Technical Journal Title Rear light condensation-information and leak test		Ref. No. TJ 36908.1.0	
Issuer (Dept.) Technical Service		Issue Date 10/10/24	Status Date 10/24/24
Car Market United States and Canada	Partner 3 US 7510 Volvo Car USA	Function Group 3530	
Function Description Lighting, rear		Page Page 1 of 5

TJ Instruction VCC-528763-2

Title	Tail lamp	Page	1 (3)
Action	Product fix	Operation number:	98777-2

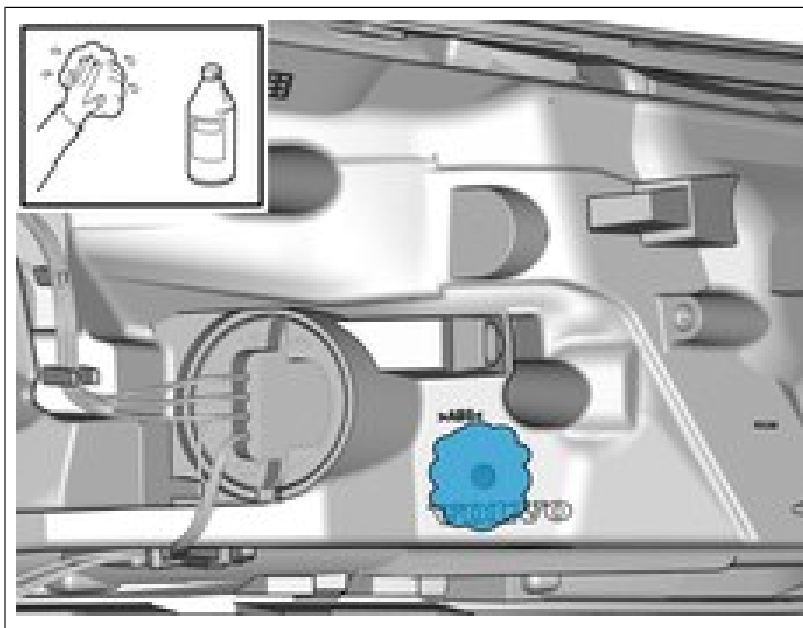
Note! Use Drill bit stopper.

Mark center according to image.

Use: Drilling machine

Use a drill with the stated size

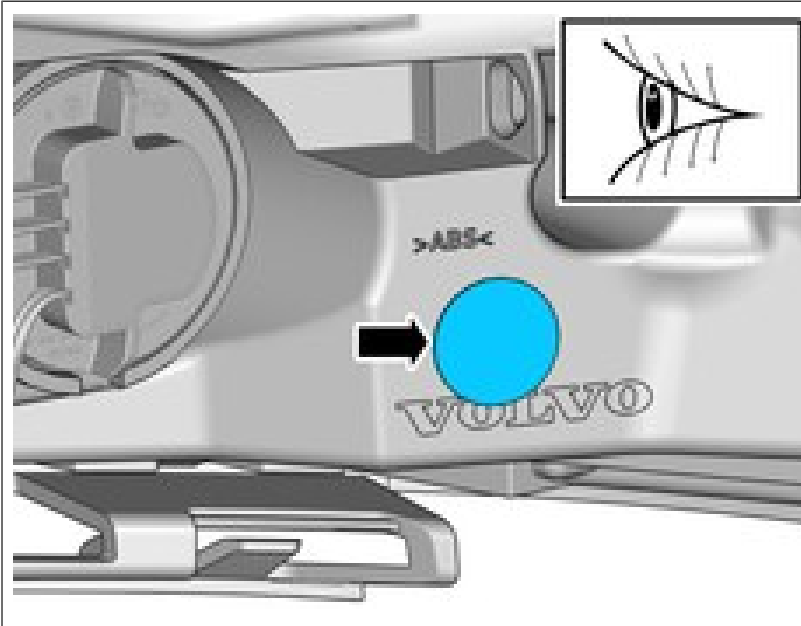
Deburr the hole edges.

Clean the marked area.

Use: Isopropanol ,

Caution! Make sure the component is fitted as illustrated.

Install new membrane.
